## PLANNING DIVISION STAFF REPORT

June 9, 2014

**Project Address:** 626 Langdon Street  
**Application Type:** Conditional Use  
**Legistar File ID #** [33685](#)  
**Prepared By:** Heather Stouder, AICP, Planning Division  
**Reviewed By:** Katherine Cornwell, AICP, Planning Division Director  
Report Includes Comments from other City Agencies, as noted

Figure 1

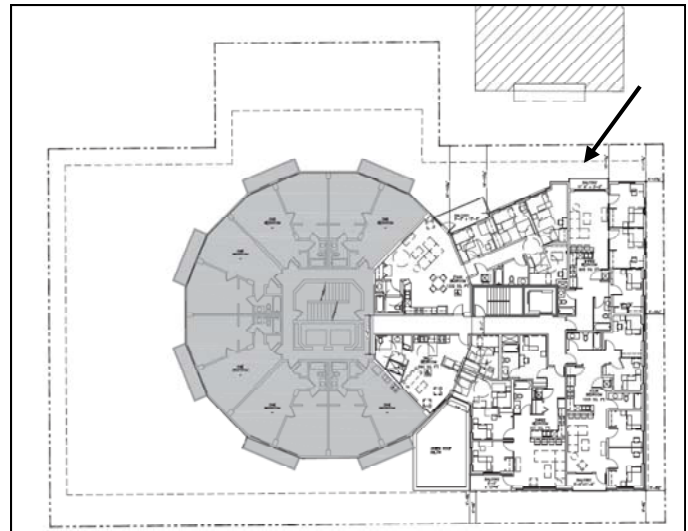
Staff does not believe the seven-foot cantilever on the side of the building is an ideal condition, but efforts by the applicant to utilize architectural strategies to make it seem more intentional are appreciated. The UDC shared no concerns about the cantilever, but staff believes that the view of this portion of the building from Langdon Street would be awkward without a grounding of the cantilevered portion of the building with columns. This would not be permissible with the electrical easement in place, and the applicant has indicated that neither an elimination of the cantilever nor a relocation of the easement would be feasible.
